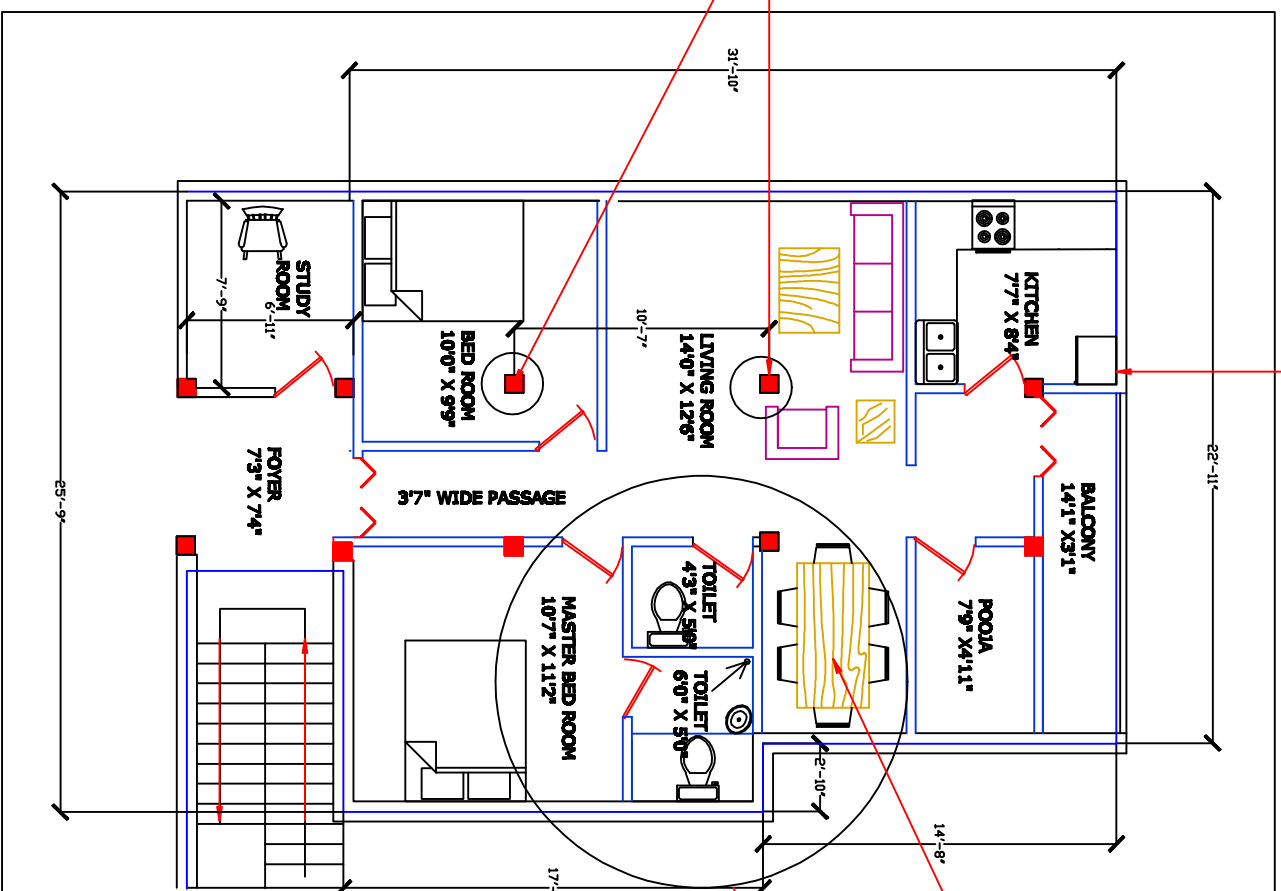
NEED COLUMN TO EXTEND THE KITCHEN TO BALCONY?

IF DEMOLISH THESE TWO COLUMNS, THEN THE LOAD BEARING CAPACITY WILL BE?

IF NO WINDOW PROVISION FOR DINNING, THEN WE WILL PROVIDE THE OTS HERE I.E FULLY COVERED WITH SUN GLASS

REMOVED THE OTS, THEN CHECK PROVISION FOR VENTILATOR, FOR SUNLIGHT.....
